Sub: RM&U Stage III HEPP: Replies to the Queries.

With reference to the above and as directed, enclosed please find herewith the Replies to the queries raised by the Bidder for the work “Rehabilitation of Hydro Mechanical and Civil Facilities (Package-II)” under the Project for “Renovation and Modernization of Umiam-Umtru Stage-III Hydroelectric Power Station”.

**PROJECT NAME: RENOVATION AND MODERNIZATION OF UMIAM-UMTRU STAGE-III HYDROELECTRIC
POWER STATION**

CONTRACT NAME: REHABILITATION OF HYDRO-MECHANICAL AND CIVIL FACILITIES (PACKAGE-II)

Figure 7-29 Survey results around the leakage point of the conduit tunnel

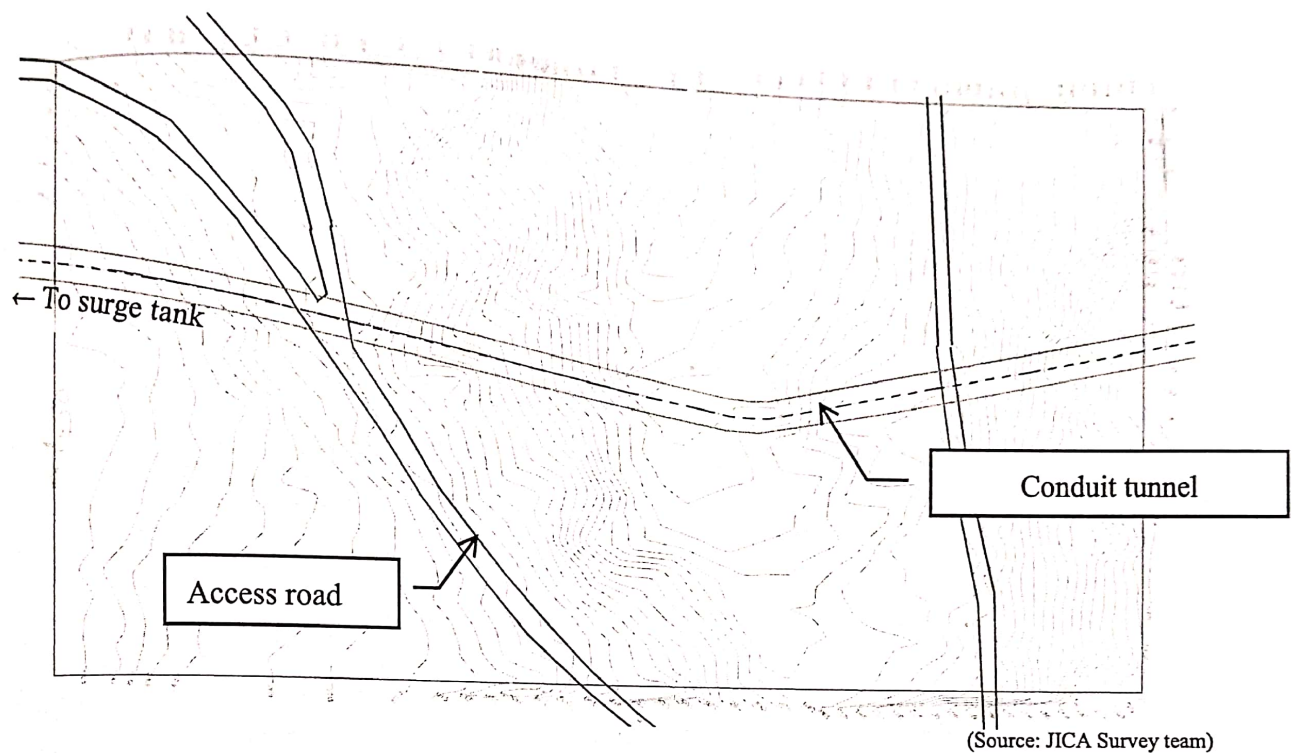
6	Related with Bill No. 6- HRT & Link Tunnel	The details of survey for repair work of Link & HRT tunnel based on which estimated quantity worked out may please be provided.	Relevant extract of Survey Report is enclosed as Annexure – A
7	Link & HRT Tunnel- Item No - 604	The quantity of 15000cum seems to be on higher side	The quantity includes removal of silt from inside the Link Tunnel, its exit into the Nongmahir Forebay and the Forebay.
8	Link & HRT Tunnel- Item No - 609	Depth of grouting may be indicated.	Contact grouting: The depth of grout holes will be equal to the thickness of lining +300mm into the rock, as provided in IS: 5878 (Part – VII) Consolidation Grouting:- Depth of grout holes is 0.75D to D , where D is the finished tunnel diameter, as per IS :5878(Part – VII) specifications.

Heavy Duty Trash Boom with walkable Floor.

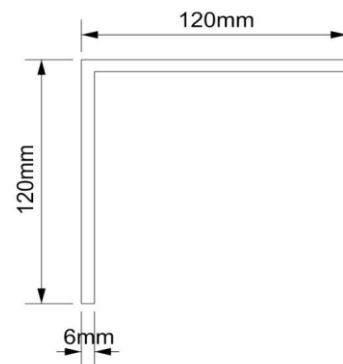
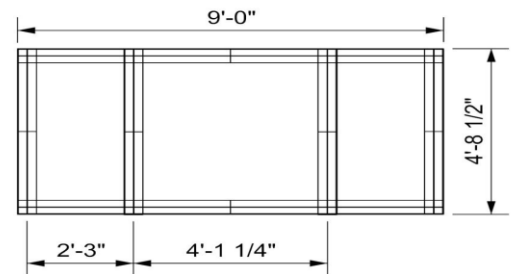
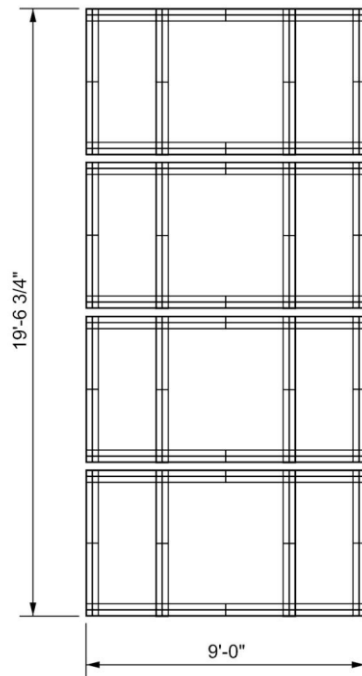
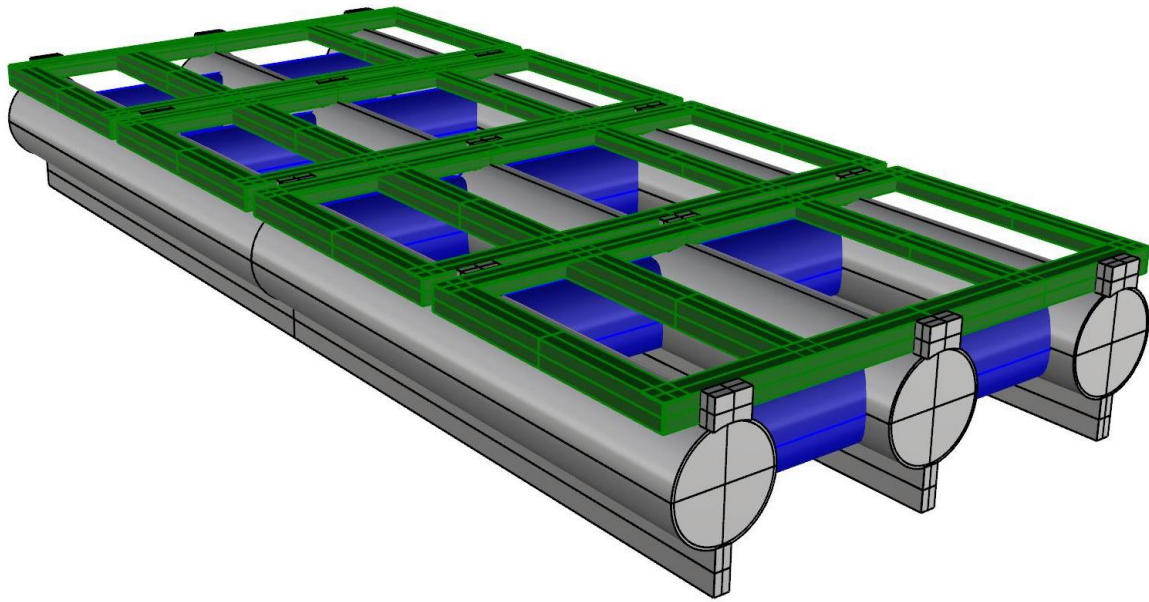
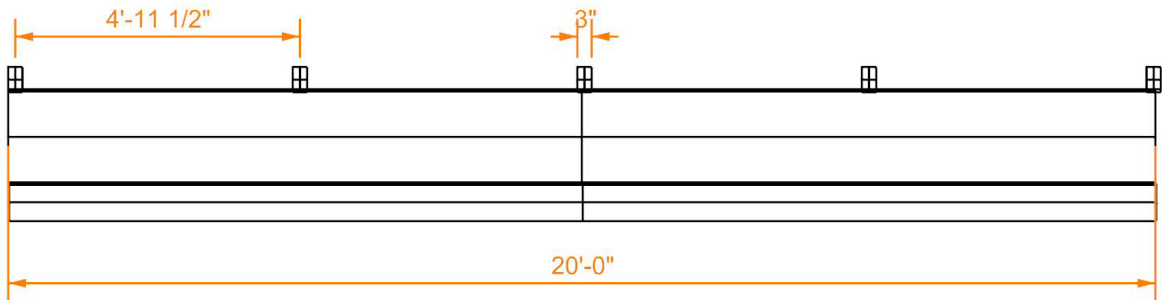
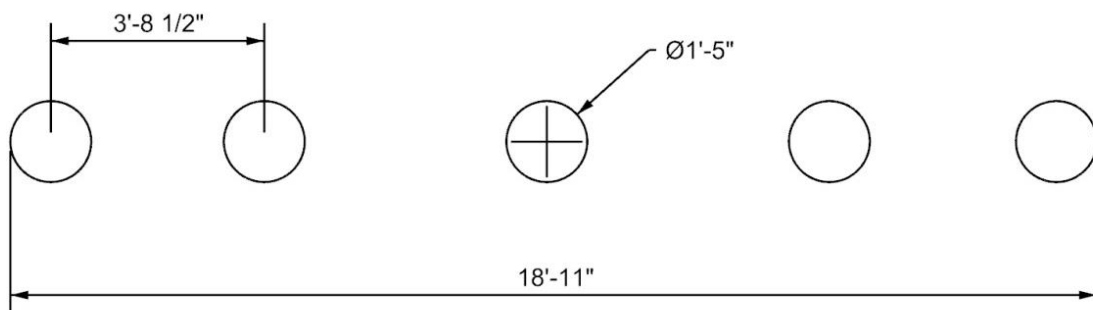
15	Bill No 30- Item No 3003 and 3004	Both items are same. Why 2 different items?	Grading of Material is different. Grading I material shall be as per MORT specifications.
16	Bill no 33. Item No 3301	Please provide drawing of LOG BOOM	Drawings enclosed as Annexure - B(i) to (x).
17	HM works-Bill No1- Item No101	Measurement of Rope drum hoist should be in numbers for a capacity of 20T. Quantity is one number only.	The number of Rope Drum Hoist is 1(one) with a capacity of 20 MT instead of quantity 20 MT.
18	HM works-Bill No1- Item No102	Pl inform size of Guide rollers	Diameter of guide rollers is 89 cm.
19	HMW- Bill No1-Item No 104	Pl inform size of seals	Drawing enclosed as Annexure – C.
20	HMW- Bill no1- Item no 109	Please provide the drawing of trash rack	Drawing of trash rack is enclosed as Annexure -D
21		The length of Head race tunnel is 601m and 3.96m as specified in site data and not 39.5m long and 3.69m dia. as indicated in tender drawings. Please confirm.	The length of the HRT is 601.69 m as shown in the tender drawings.The diameter is 3.96 m.
